Access Compliance Report

Public Rights-of-Way

(Curb Ramps)

Intersection ID: 11140	Main Street: N_SYCAMORE_ST	Cross Street: W_5TH_ST	Location: E
ADA ID: 8119375DBE22	Ramp Type: PerpDiag	Initial Pass/Fail: Fail	Overall Compliance: No
			Severity Score: 48.75

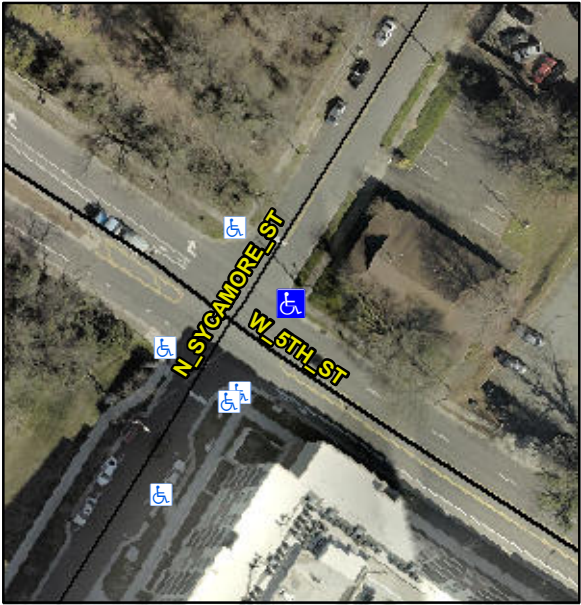
Codes/Mitigation Info/Possible Solution			Field Measurements/Component Compliance		
	Possible Solutions:		Compliance	Description	Data
	Remove & Replace Curb Ramp With Two New Directional Ramps or Equivalent.		N/A	Ramp Length (in)	86.0
			No	Ramp Width (in)	24.0
			N/A	Flare Type LT	N/A
			N/A	Flare Slope LT (%)	N/A
			N/A	Flare Traversable LT?	N/A
			N/A	Landing Length (in)	N/A
			N/A	Landing Width (in)	N/A
			N/A	Landing Slope (%)	N/A
			N/A	Landing X Slope (%)	N/A
<p>Surveyor Notes:</p> <p>N/A</p> <p>PROW/ADA:</p> <p>Not Found, R304.5.1, R304.2.2, R304.5.3</p>			N/A	Flare Type RT	N/A
			N/A	Flare Slope RT (%)	N/A
			N/A	Flare Traversable RT?	N/A
			N/A	DWS Provided?	N/A
			N/A	DWS Contrast?	N/A
			N/A	DWS Length (in)	N/A
			N/A	DWS Full Width?	N/A
			N/A	DWS Offset (in)	N/A
			N/A	Shared Landing?	N/A
			N/A	Gutter Ponding?	N/A
			N/A	Gutter Lip Ht (in)	N/A
			N/A	Painted X Walk1?	No
				X Walk 1 Direction	To NW

N/A	X Walk 1 Width (in)	N/A
				X Walk 1 Slope (%)	3.8
				X Walk 1 X Slope (%)	2.4
			N/A	Ramp inside XWalk1?	N/A
				Road Slope (%)	4.2
				Road X Slope (%)	1.3
			N/A	Any Obstructions?	N/A
				Obstruction Type	
Total Cost:		\$ 3200.00			
			N/A		N/A
			Yes	Surface Condition? (G/P)	Good
